Review comments on EGUSPHERE-2025-4567 (for Hydrology and Earth System Sciences)

Reviewer Comment 1: Eric Rosa, 07 January 2026

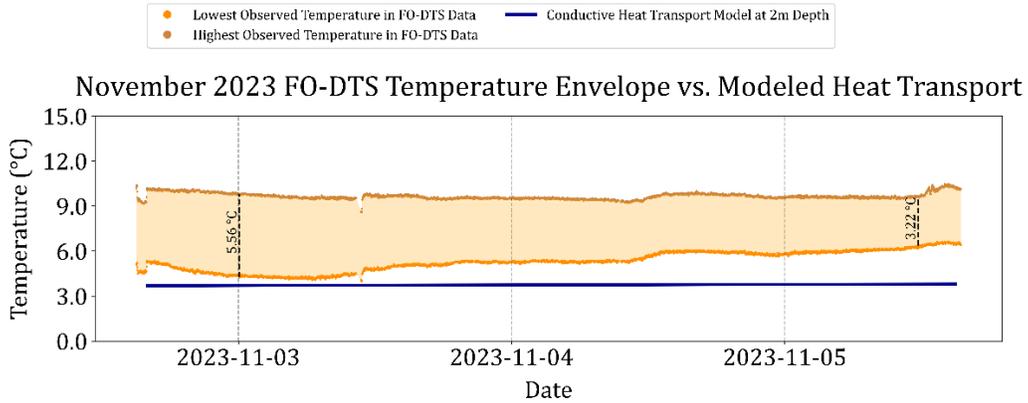
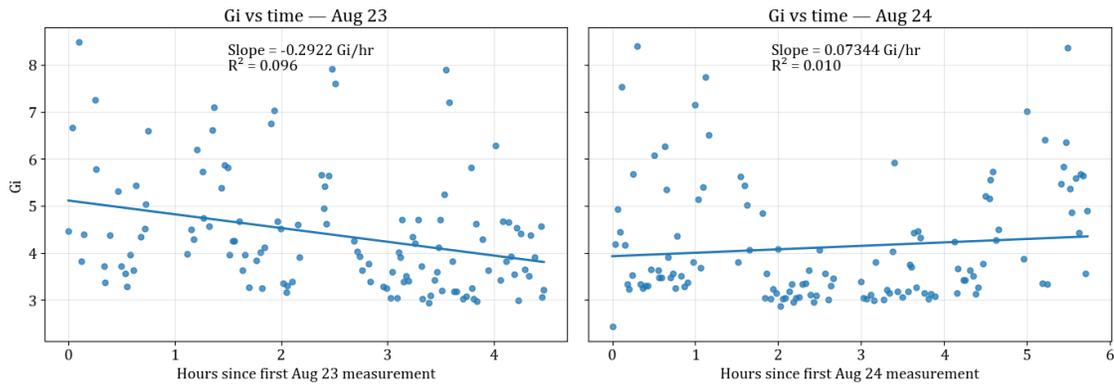
Comment: It is stated (L213) that specific conductivity and temperature measurements were conducted at a 25 cm depth a few centimeters from the pools perimeter. This choice is likely justified by the enhanced accessibility of the sites close to pool margins. However, it is important to consider the possibility that measurements taken in the immediate vicinity of the pool margins may not be representative of the conditions prevailing towards the centre of the pools, especially at greater depths. Could thermal stratification occur in some pools, with cold water at the bottom and warmer water at the surface?

- You are correct about the temperature and specific conductivity measurements being taken along the edges of the pools for the enhanced accessibility to the site to collect a representative sample size. This limitation is now recognized in Line 214 to Line 215 with the addition of "Due to the significant area of the pool systems, temperature and SpC data were not collected in the center of the pools.". Consistent measurements at 0.25 meters depth were conducted to limit surficial influences of the diurnal signal on the recorded temperature and *SpC* data. Thermal stratification is likely to occur in some of these pools, however the advective heat transport signal from groundwater discharges would still provide contrast along the pool margins due to the different heat transport processes occurring. Ongoing research, including preliminary FO-DTS observations, demonstrate that seasonal temperatures deviate from conductive heat-transport model predictions, indicating advective heat transport from depth. An example is provided

below from FO-DTS data collected during the November 2023 season, where warmer water was expected to indicate advective heat transport along the base of the pools.

Gi vs time — Aug 23 / Gi vs time — Aug 24

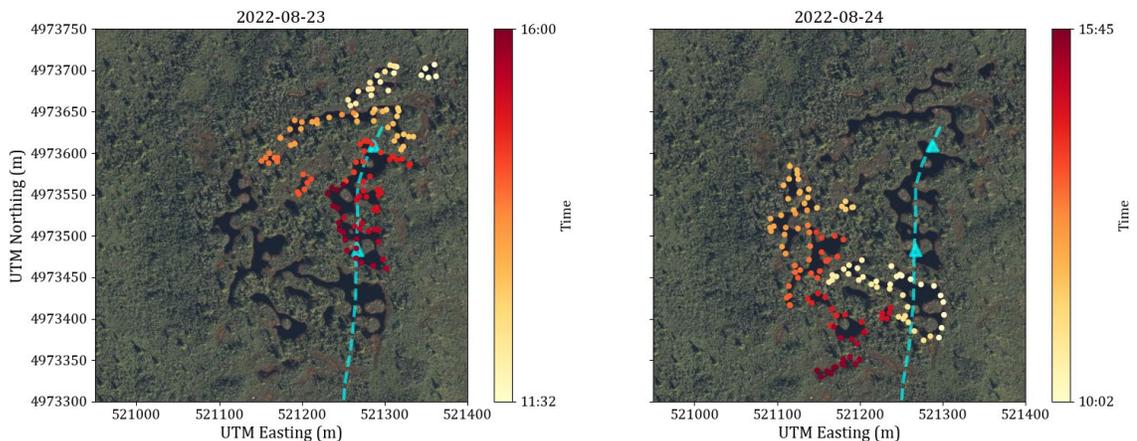
Comment: A variety of measurements were conducted on different days at multiple sites. It is to be considered whether there has been a change in the temperature of surface water in pools during the period of measurement. To illustrate this point, if measurements are conducted in August, can stable temperatures be expected between the early morning and the afternoon across all measurement points? The potential impact of temporal variability, i.e. variations in surface water temperature during the day of sampling, on the comparisons between different sampling points merits consideration.

- This is a valid concern regarding the temporal nature of the point measurements made, however the *Gi* variable defined from these measurements is emphasized to be used as a tracer for advective heat transport rather than a hard quantitative measure. The SpC measurements made would also be less susceptible to daily changes overall. It is further emphasized that collecting this representative sample size of points would not be feasible in such remote settings, and especially not in three separate regional bogs. This warrants the use of the *Gi* variable to display contrasts in space rather than in time. Provided below shows an example plot of the data collected with time in Caribou Bog, which shows no visible spatial correlation with the Groundwater Indicator variable presented in Figure 6.

A linear regression was carried out between the *Gi* variables over time to investigate any relationship and no statistical correlation was found, with visible spread of the *Gi* data.

Slope = -0.2922 Gi/hr, R^2 = 0.096 (Aug 23)
Slope = 0.07344 Gi/hr, R^2 = 0.010 (Aug 24)

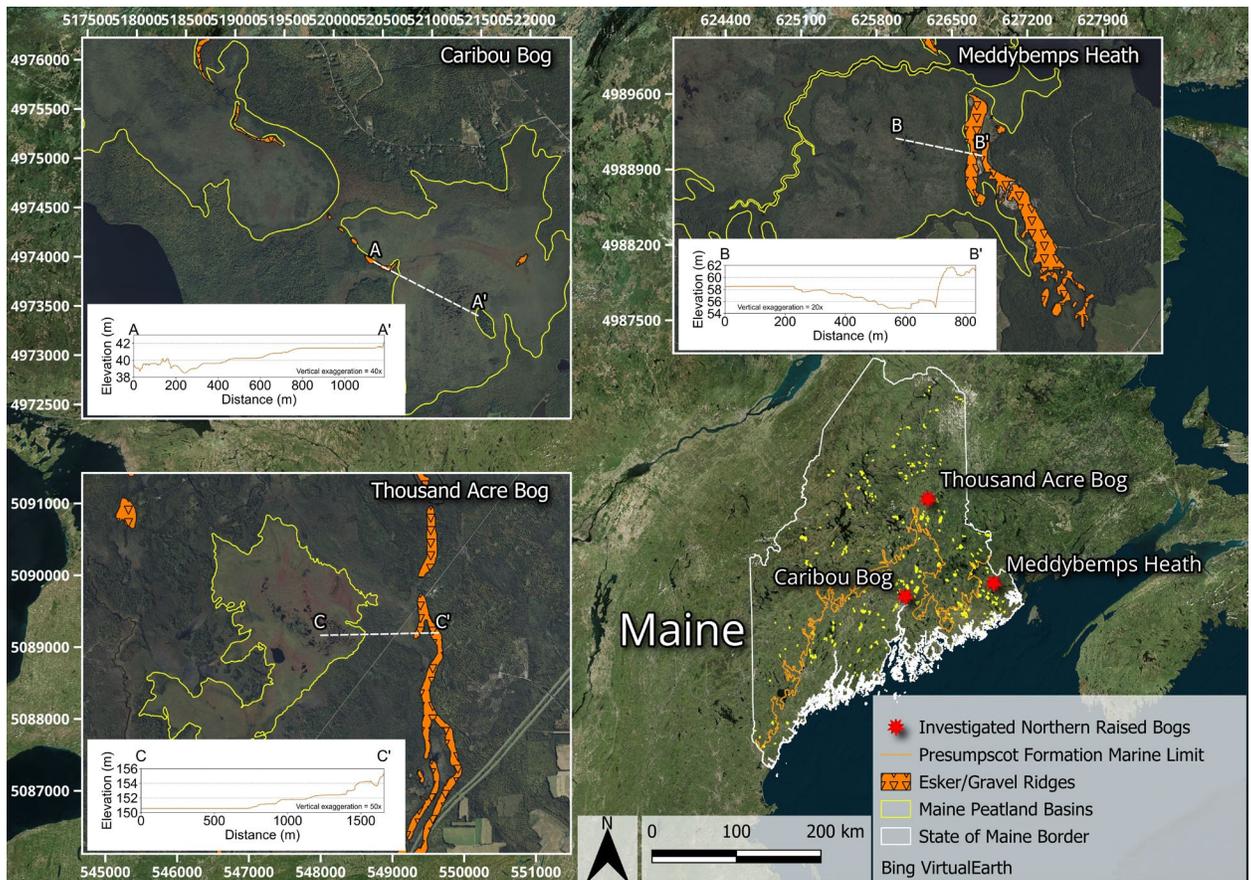
<u>General Comment 2:</u> Should it be feasible, it would be of interest to present the precise topographic contours for the peatlands under study. Some figures illustrate upgradient and downgradient areas (e.g., Figure 2); however, it is probable that the flow configuration is more intricate than what is visible in the image. The incorporation of topographic contours (e.g., derived from Lidar data) would facilitate enhanced comprehension of the surface flow paths between pools. This would further facilitate the comprehension of the hydraulic head data presented in Figure S16 and the general pattern illustrated in the conceptual model (Figure 10).

Comment: If possible, it would be relevant to provide an estimate of the topographic gradient between the esker and the lagg and between the central part of the peatland and the lagg.

- Thank you for your suggestion, elevation profiles through the patterned pools investigated and to the nearest mapped surficial esker deposit are now presented in Figure 1. However, these elevation profiles do not change the basic interpretation of the hydraulically upgradient/downgradient pools. The flow configuration is likely more intricate as you describe, however this is now aimed at guiding the reader with additional support for the conceptual model in Figure 10.

- Topographic profiles between the nearest esker deposit, corresponding lagg, and the center of the peatland (relative to the pools) are presented in Figure 1.

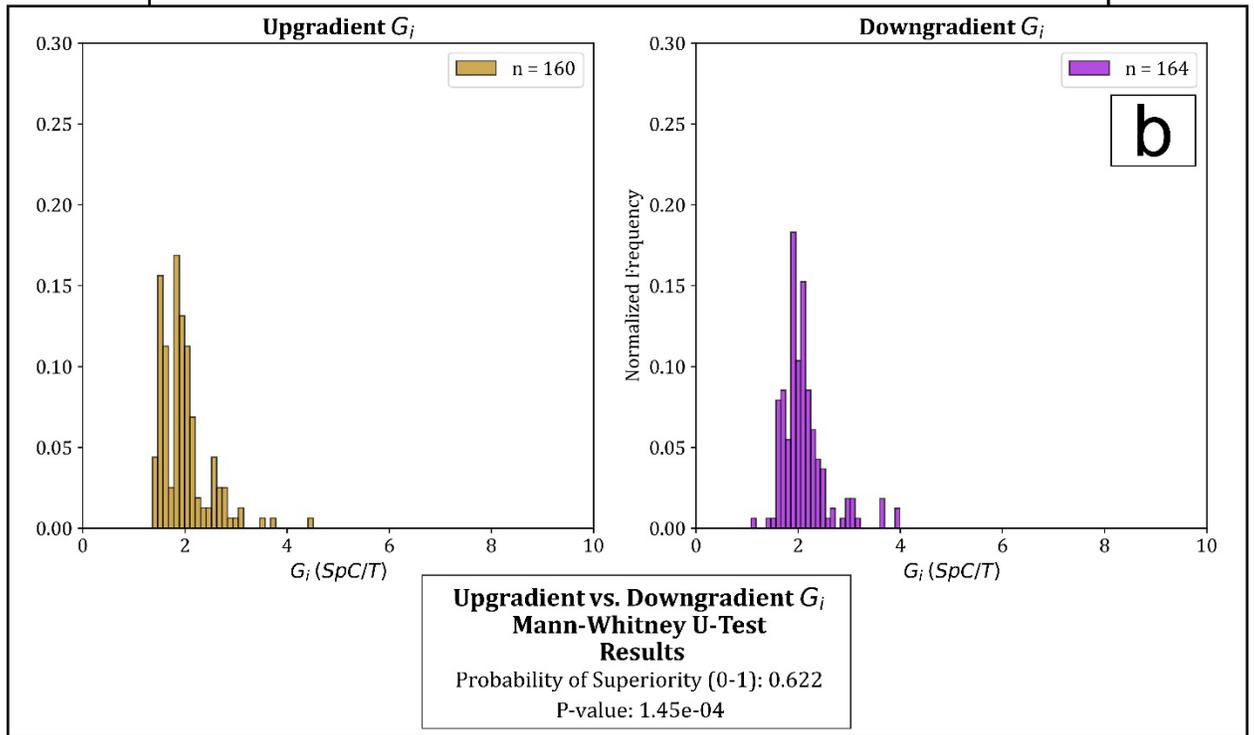
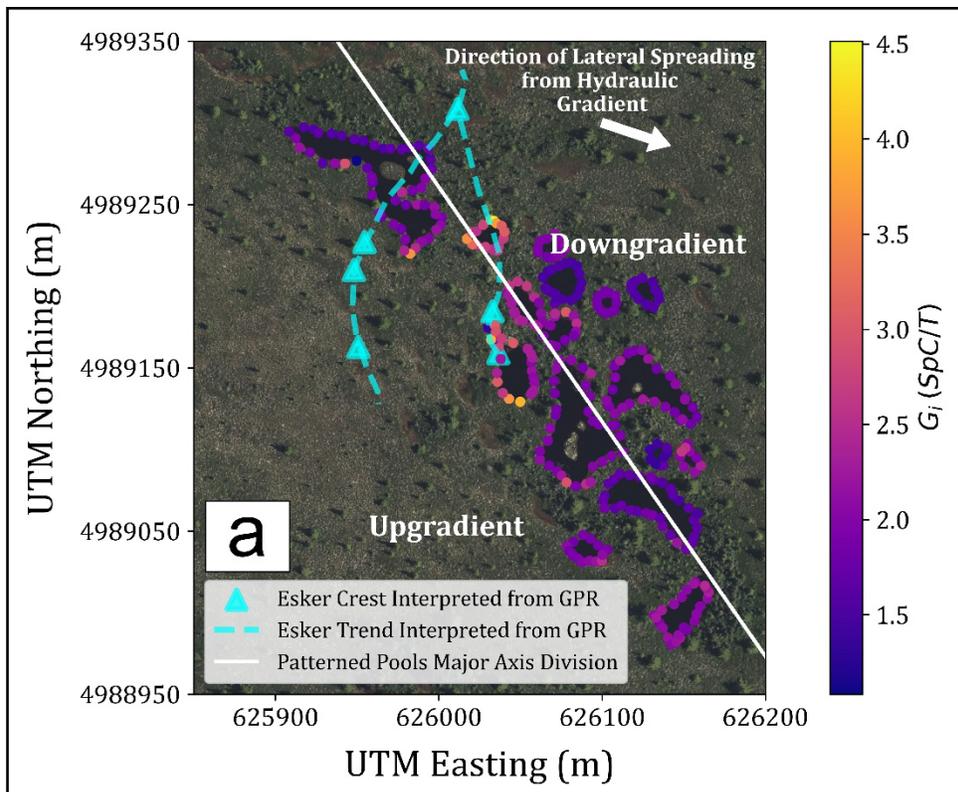
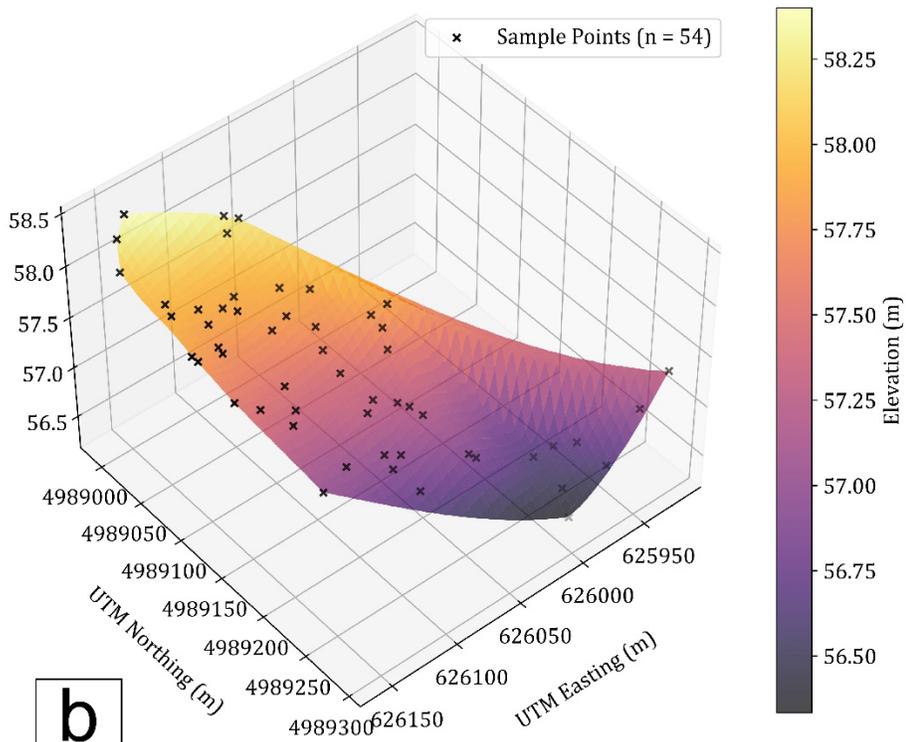
Comment: Figure S9 : I am having difficulty understanding how the arrow is oriented in relation to the up- and down-gradient areas. Please could you double-check this?

- After double-checking this arrow, the angle has been updated to reflect the direction of the downgradient side of the pools.

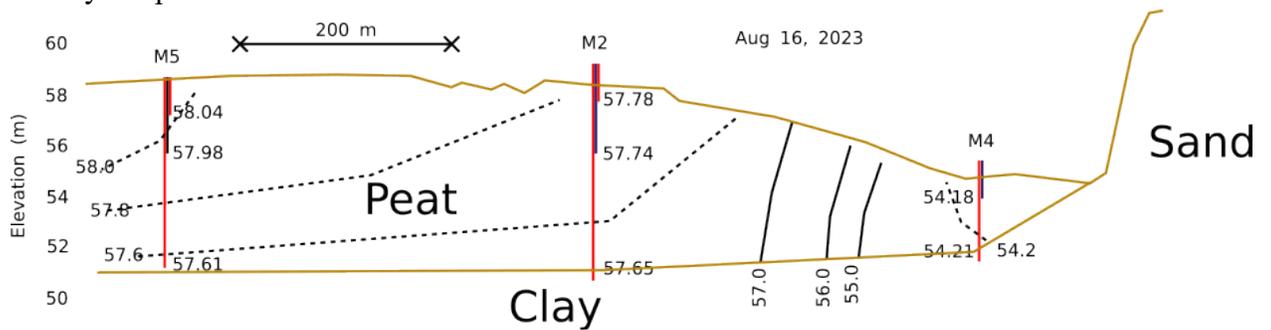
Comment: Figure S15 : I recommend revising the text that appears on the images "3D Surface Plot of Hydraulic Gradient...". I believe the text in the caption should suffice.

- Agreed, thank you for this suggestion. The titles on the plots have been removed.

- **Figure S17: Hydraulic head contours between wells MB5 and MB2 crossing the patterned pools of Meddybemps Heath on August 16[th], 2023, showing downwelling between the wells. Downwelling patterns in the hydrological data persist until the lagg with the transition to esker sand.**

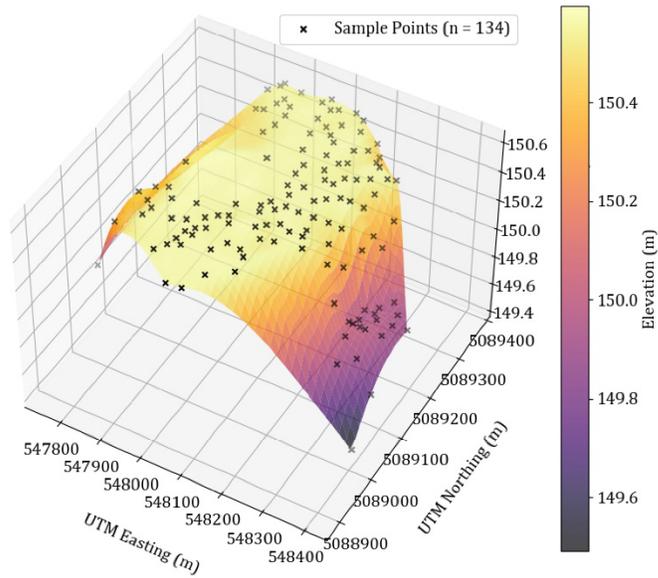
Comment: Figure S17 : The hydraulic head contours proposed therein appear to be oversimplified.

- An updated Figure S17 has been provided from ongoing hydrological modeling of the Meddybemps Heath based on well data.
